Government Land Standing Advisory Committee

Tranche 8 Report

Former Peter MacCallum Cancer Centre

19 October 2017

Figure 4: Proposed DDO building envelope

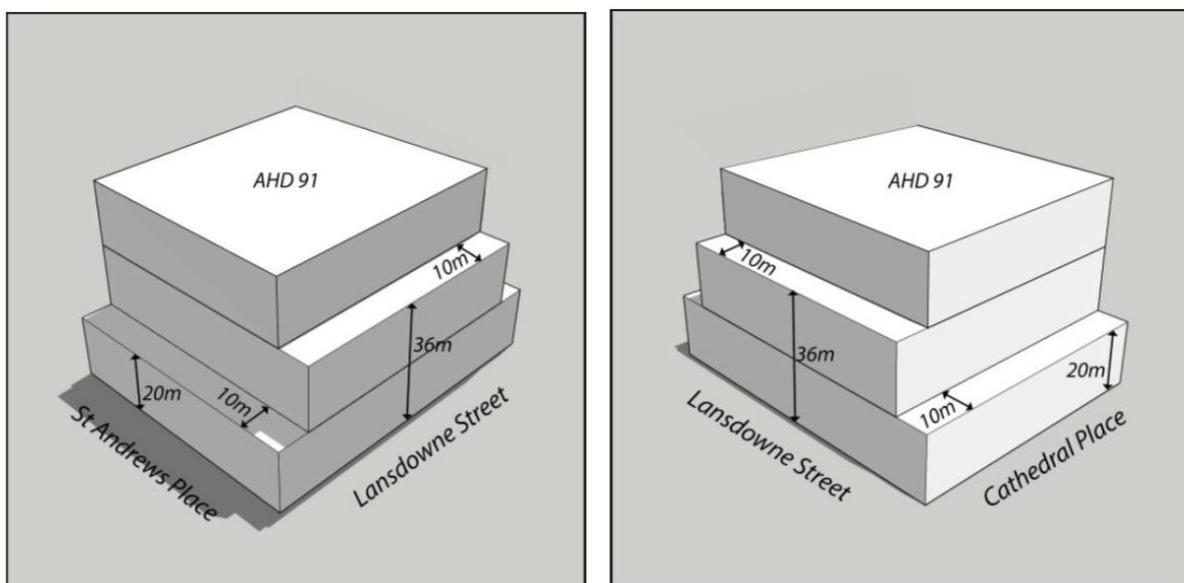
The building envelope that results from the controls in the DDO is shown in Figure 4 which is taken from the DDO.

In the context of revised built form parameters that include a 55 metre height limit over only part of the site, overshadowing controls and increased setbacks, the Committee thinks it is clear that the FAR of 9:1 is not realistic or achievable. Different submissions have suggested reduced FARs of 6:1, 7:1 and 8:1, however, these are supported with little strategic justification. The Committee has not been provided with evidence as to what FAR may be achieved as a result of the revised built form parameters recommended in submissions and evidence. In the absence of this, the Committee is not prepared to recommend an alternate FAR, and believes that the FAR control should be removed from the DDO. The Committee considers specifying a FAR is likely get in the way of achieving an acceptable built form outcome.

4. Apply a new schedule to the Design and Development Overlay as shown in Appendix D with the following changes from the exhibited version:

4.1 Allow buildings to exceed AHD 91 provided the iconic viewlines are protected.

4.2 Specify the following streetwall heights:

- **For the Lansdowne Street streetwall:**
 - no prescribed ground level setbacks
 - a discretionary streetwall height of 24 metres
 - a discretionary setback above the streetwall of 25 metres
- **For the St Andrews Place streetwall:**
 - a discretionary ground level setback of 4 metres
 - a discretionary streetwall height of 20 metres
 - a discretionary setback above the streetwall of 10 metres
- **For the Cathedral Place streetwall:**
 - a discretionary ground level set back of 4 metres
 - a discretionary streetwall height of 20 metres
 - a discretionary setback above the streetwall of 10 metres.

Figure 5: Key vistas

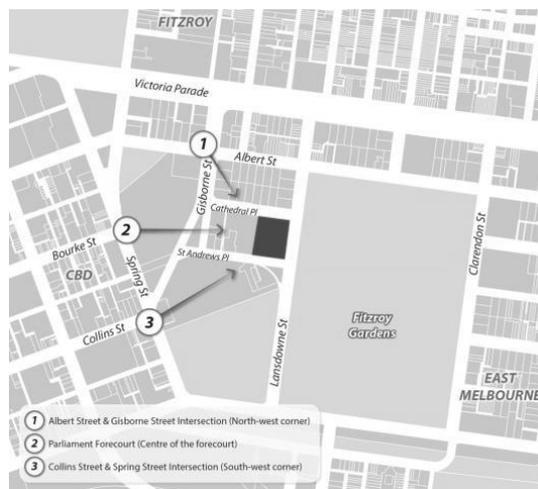
The three principal views identified for protection are shown in Figure 5.

The East Melbourne Historical Society and Dr Rushen submitted that the proposal would negatively impact the views to Saint Patrick’s Cathedral.

The overall height of AHD 91 was based on an analysis of views identified in the planning scheme. The site owner submitted:

Figure 2: Sightline view points

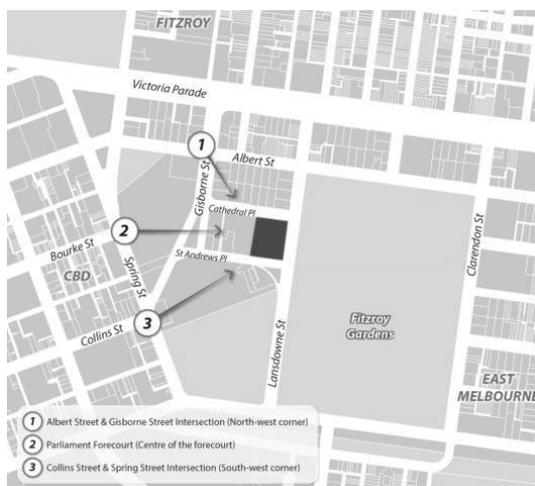
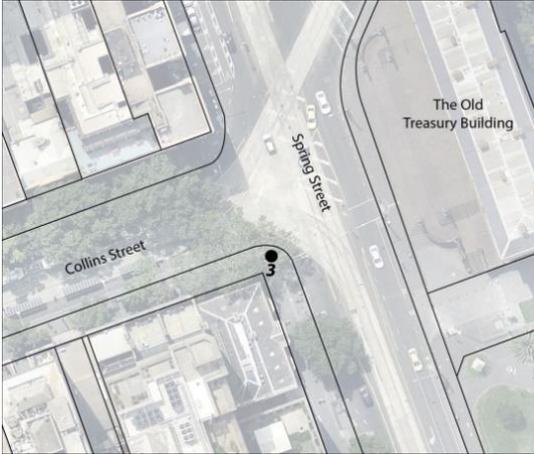
Buildings must not be visible when viewed from the sightline viewpoints in Figure 2:

Prepare revised diagram

DELETE AXONOMETRIC VIEWS

- bring it into compliance with the *Ministerial Direction on The Form and Content of Planning Schemes*
- delete the axonometric diagrams
- improve the drafting.
